Service Information Letter

Units Affected: DC1317 and DRM12 Chippers Using V3600T and V3800T Kubota Engines
 (see attached list)

Engine Air Intake Modification

Figure 3 — Inspection Area

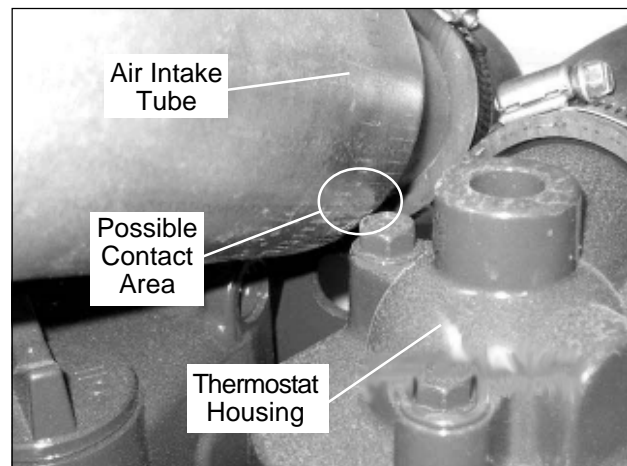
On some engines the air intake tube can rub on a thermostat housing cap screw head under the engine cover. Over time the contact can create a hole in the air intake tube allowing debris to be sucked into the air intake of the engine and possibly damage the turbocharger or the engine. The chipper engine distributor has supplied Altec with an update kit that will hold the air intake off of the top of the engine and away from any components that it could rub against. This update kit should be installed on all chipper engines on the attached list.

4. Look at the point where the intake tube passes near the thermostat housing. One of the cap screws attaching the thermostat housing will be very close, if not touching, the intake tube (refer to Figure 3).

5. Inspect the air intake tube at the point where it is close to the cap screw. If there is any contact between the tube and the cap screw head, look for any evidence of damage in the air intake tube.

6. If there is any evidence of damage or a hole in the air intake tube, remove the chipper from service and install the correct Update Kit kit, which includes a replacement hose, for the model of engine affected. If the air intake pipe is damaged remove the hose clamps at the air cleaner outlet and turbocharger inlet. Remove the air intake tube and inspect the turbocharger for damaged compressor blades. If there is any damage to the turbocharger compressor blades, contact the Altec Forestry Support Call Center (IFlyAltec) 1-877-435-9258 or email IFlyAltec.com for Technical Support to report the damage and get further direction.

7. If there is no evidence of damage or a hole in the air intake tube, install the correct air intake update kit for the model of engine affected at the next service interval.
